Town of Milton

January 8, 2020

Runway 4R RNAV Study Requests

Example of Deterministic 4R Arrival Dispersion N Above Exposure

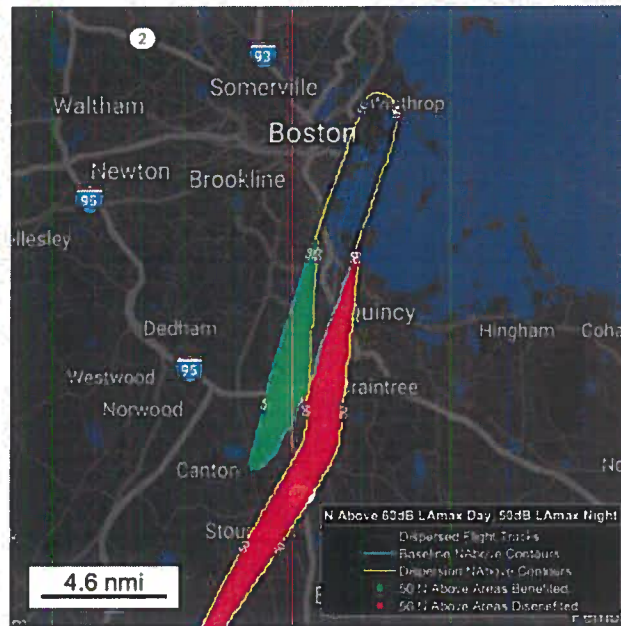
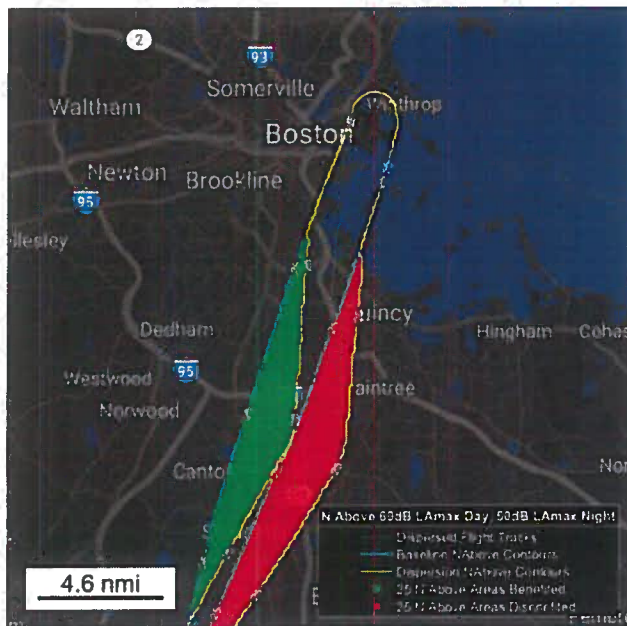
The MIT slides each show a modeled path shift and population affect count, but do not include the requested census block comparison of the modeled additional 4R RNAV path with noise effect upon the same residential areas under the **pre-RNAV** 4R overflights that previously affected them and no longer do. Restoring dispersion restores noise burden sharing. We recognize that pre-RNAV census block comparisons for all of the MIT slides would not be needed if the paths illustrated can first be ranked by the MIT consultants in order of flyability. Some 33L residents have sought similar baseline census block noise data for their dispersion analyses. Similarly, we request that the highest ranked MIT illustrated alternative 4R path(s) be compared with **pre-RNAV** overflights of the same respective areas, so that an alternative path can be pursued as a back-up to pursuit of the preferred dispersion path (slides 1,2,3) if need be.
